49 REEVES WAY WOKINGHAM RG41 2PS

Application Number: 260063

**PROPOSED ERECTION OF A SINGLE STOREY REAR EXTENSION FOLLOWING DEMOLITION OF THE EXISTING CONSERVATORY, PLUS CHANGES TO FENESTRATION**

Objections to planning application 260063 at 49 Reeves Way

Current planning application showing relative size and mass of proposed extension causing visual impact, eye-sore and loss of aerial light to 47 Reeves Way

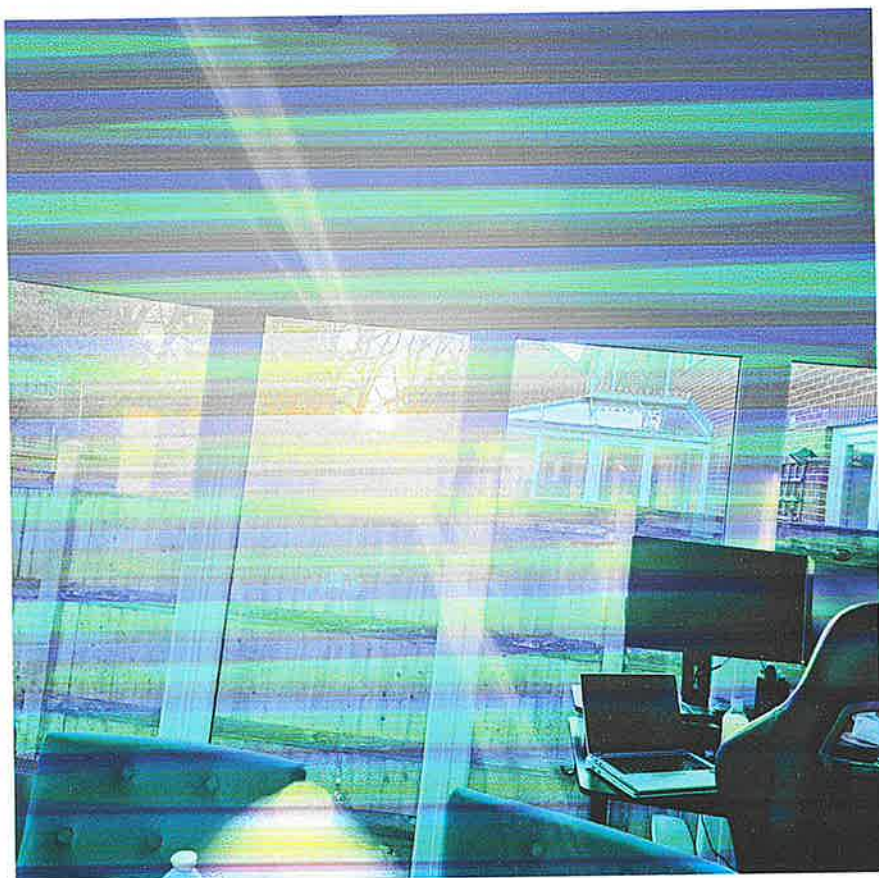
While I understand the applicants' desire to increase their ground-floor space, the extension in its current form is, in my view, disproportionately large. From our property at 47 Reeves Way, the outlook from our conservatory (used daily as a dining room/office) would be dominated by a tall, uninterrupted brick wall. This is primarily due to the proposed single-pitch roof which rises towards the rear of No. 49, resulting in two substantial brick side elevations reaching up to just below the first-floor windows.

I would strongly prefer a hipped-roof design, with three sloping roof sections, as illustrated on the diagram that will accompany the hard-copy version of this objection. A hipped roof—sloping inwards from both sides as well as the rear—would reduce the imposing height and length of the structure along the boundary and significantly soften its visual impact.

I would also like to highlight that the gap between the proposed extension and the boundary line separating our two properties is approximately 1000mm. I believe the 2-Metre Rule applies here, meaning the eaves height must not exceed 3 metres. Given this, I feel that a reduction in both the depth (from 4365mm to 4000mm) and the width (from 11785mm to 9785mm) should also be considered. As proposed, the extension would severely limit the natural light entering our conservatory. My calculations indicate that it would block around 82% of our side light and obstruct the view by approximately 3470mm.

Suggestions of changes to planning application on the grounds of: planning rules, lessening of size, visual impact and loss of light to 47 Reeves Way

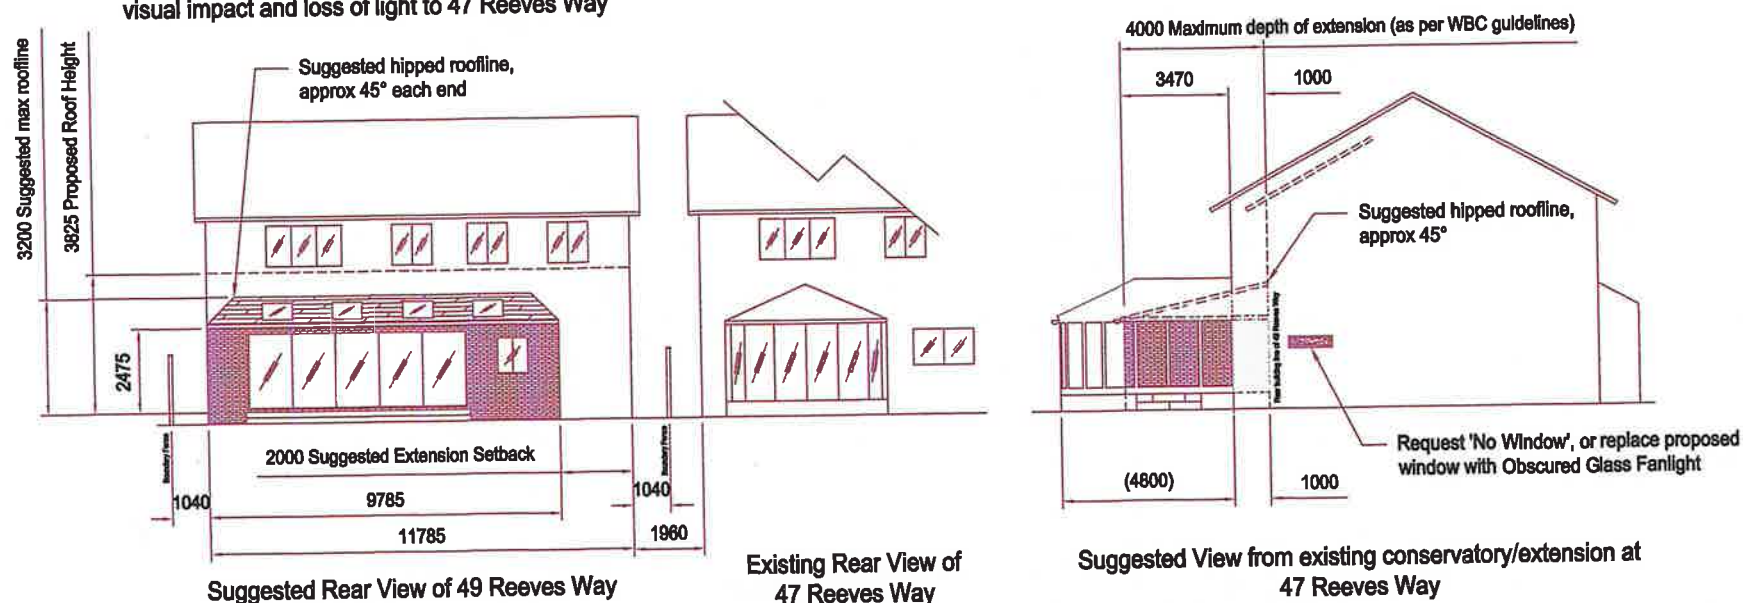
To mitigate this, I have suggested a 2000mm reduction in width—moving the extension further away from our shared boundary—to prevent the structure from appearing excessively dominant. These amended dimensions are shown on the diagram that will be submitted with the printed copy of this objection. A photograph illustrating the current light levels from the side of our conservatory, which would be lost under the proposal, will also be included.

I therefore object to this window in its current form and would prefer it either to be removed completely or replaced with an obscured-glass fanlight window, which would prevent direct overlooking while still allowing ventilation if required.
